# DRAFT RESOLUTION

In the matter of the application of:
**MCDOUGALL AMY E. (PLN230127)**
**RESOLUTION NO. 24--**
Resolution by the Monterey County Planning Commission:

[PLN230127, McDougall Amy E., 10196 Oakwood Circle, Carmel, Carmel Valley Master Plan, (APN: 416-542-011-000)]

10196 Oakwood Circle - Oakshire Tract 1045 - Carmel Valley Ranch

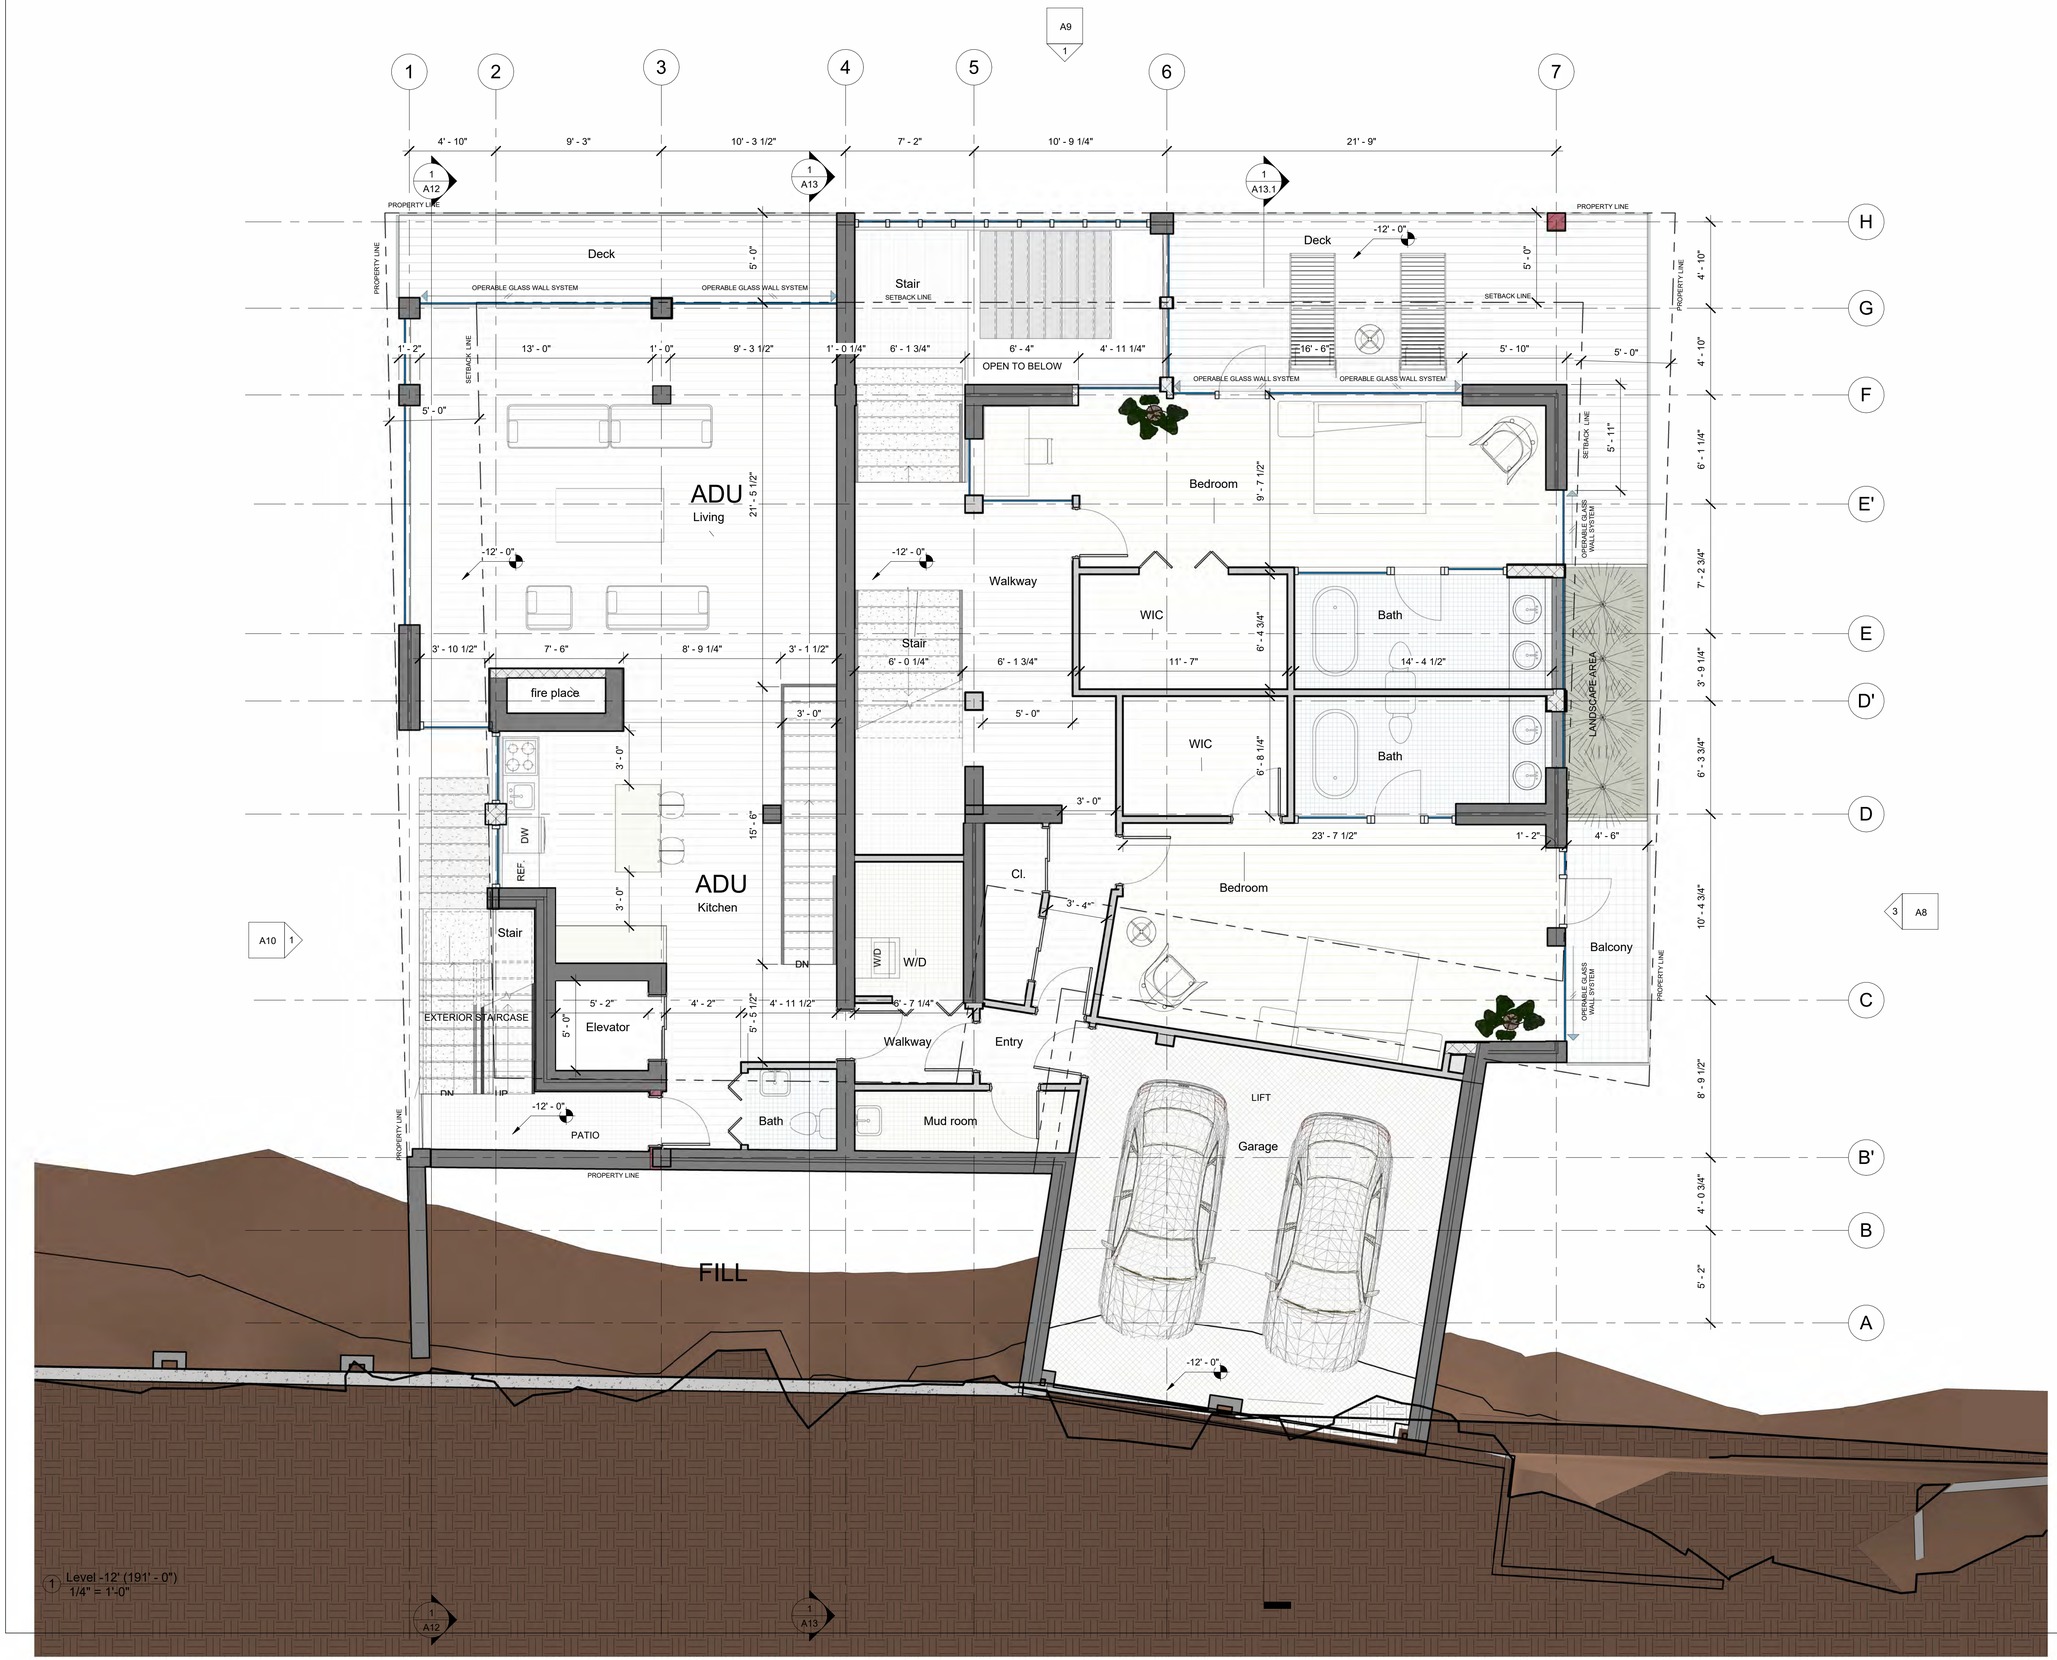
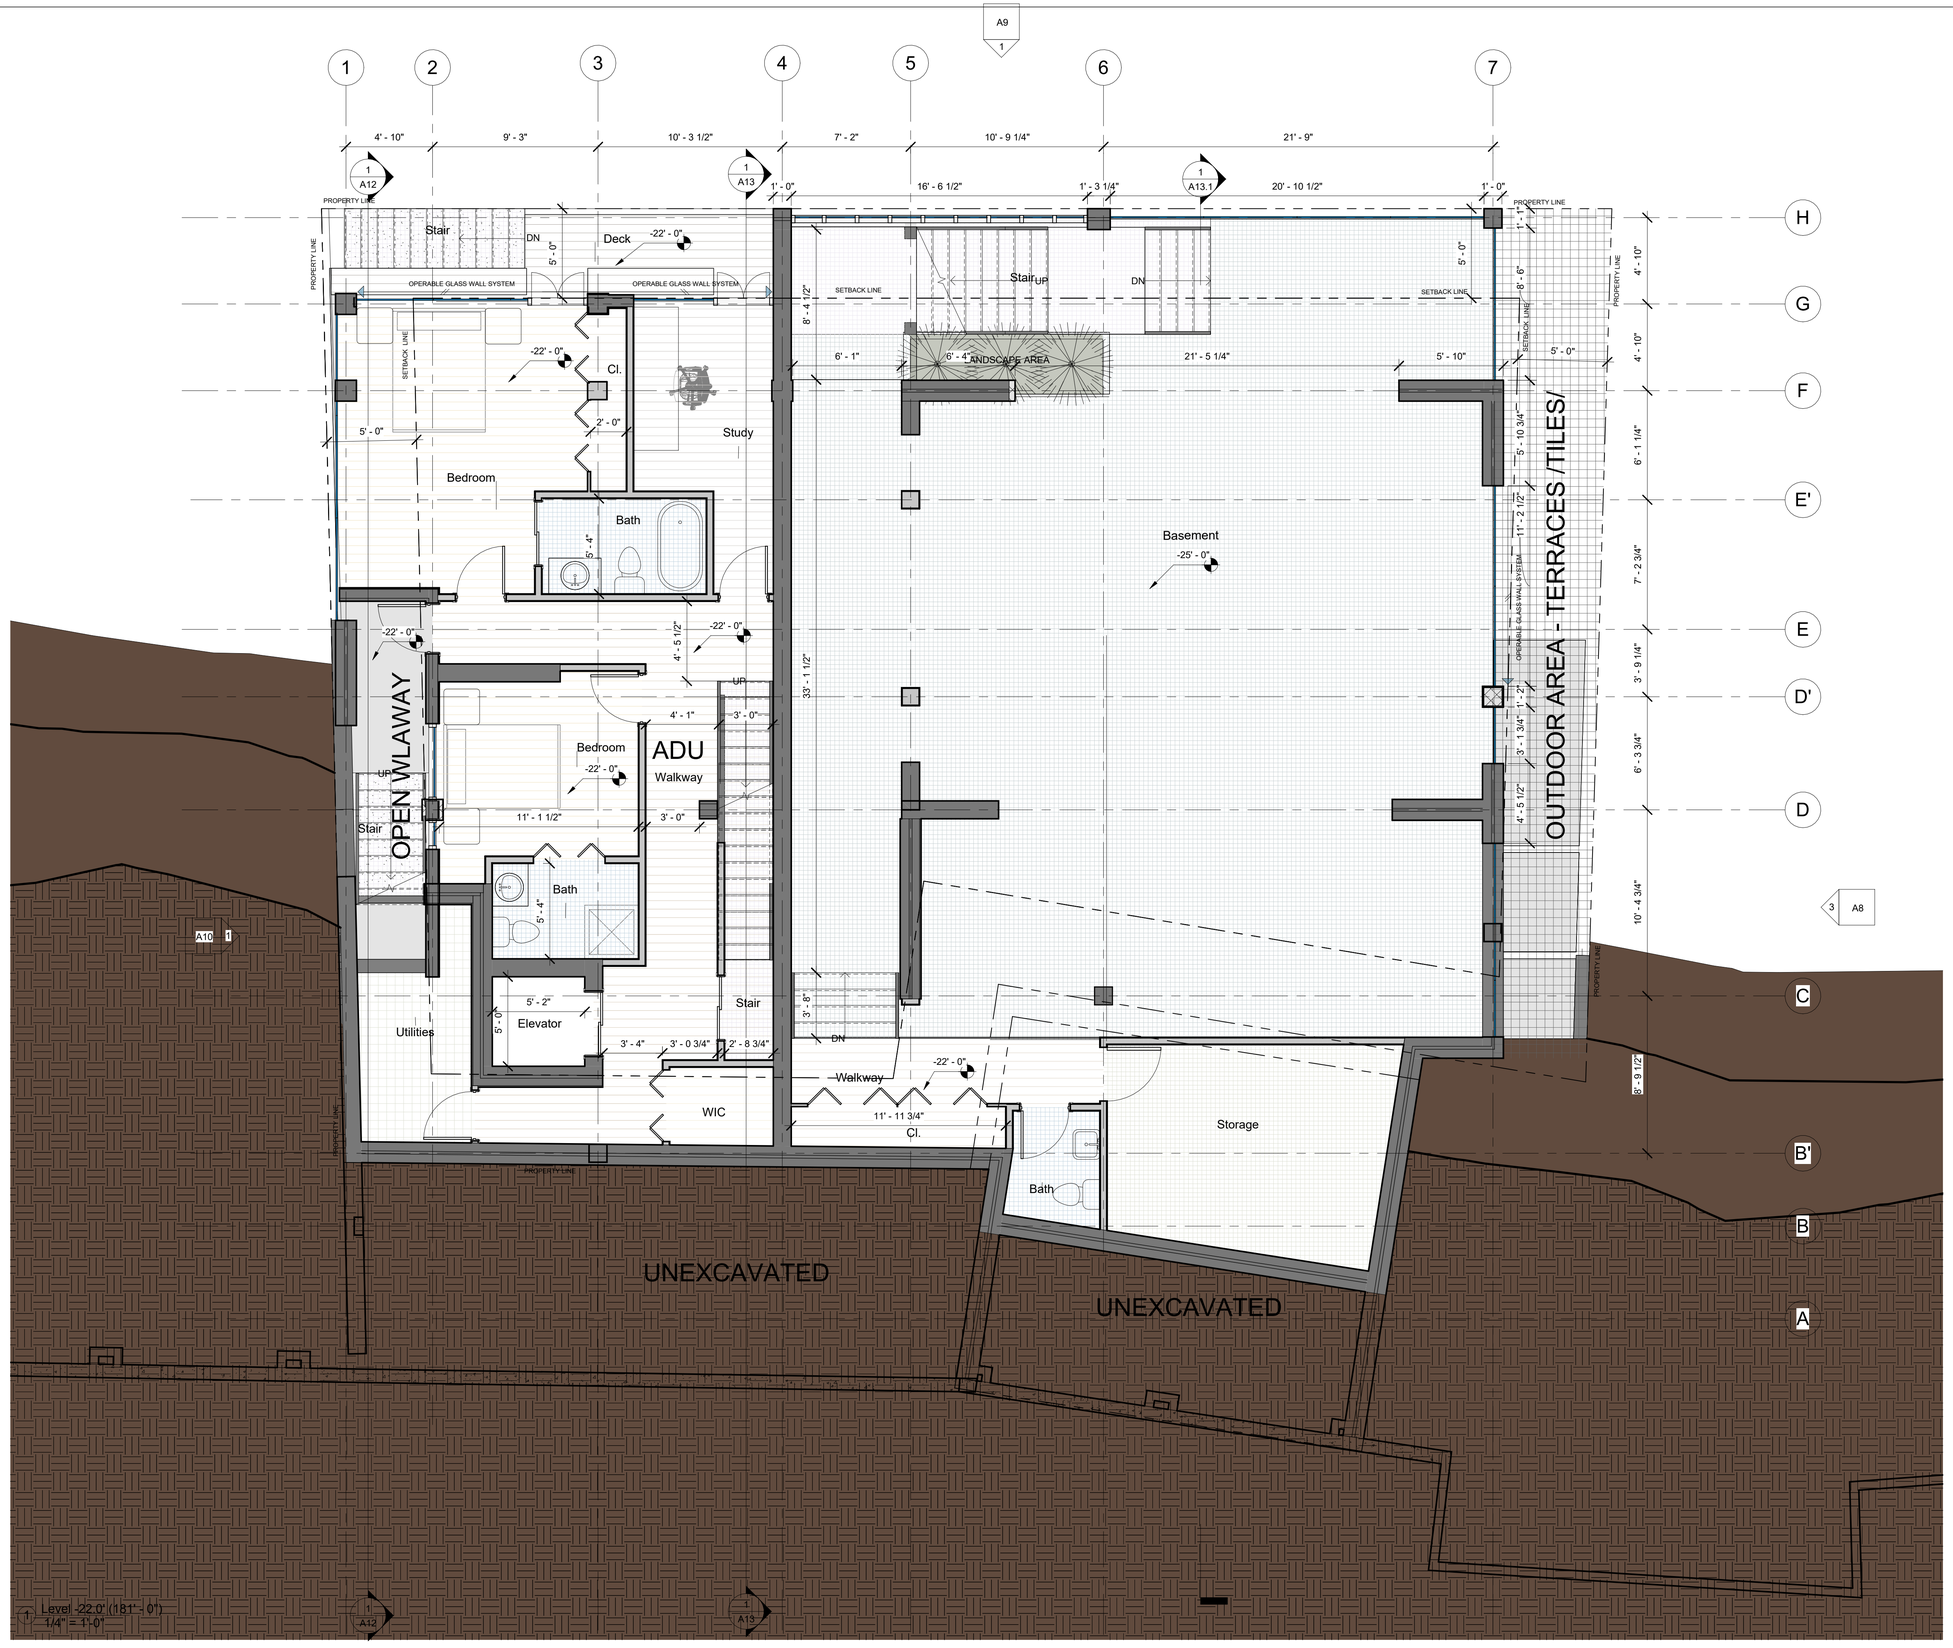
d) Although the proposed ADU has exterior access via a series of staircases, the ADU also has internal circulation with the main residence (see Sheet A5). Additionally, the lower-level basement and well room are only accessible via the ADU. Consequently, the proposed ADU is inconsistent with the requirement that ADUs be independent living quarters that lack internal circulation with the main residence.
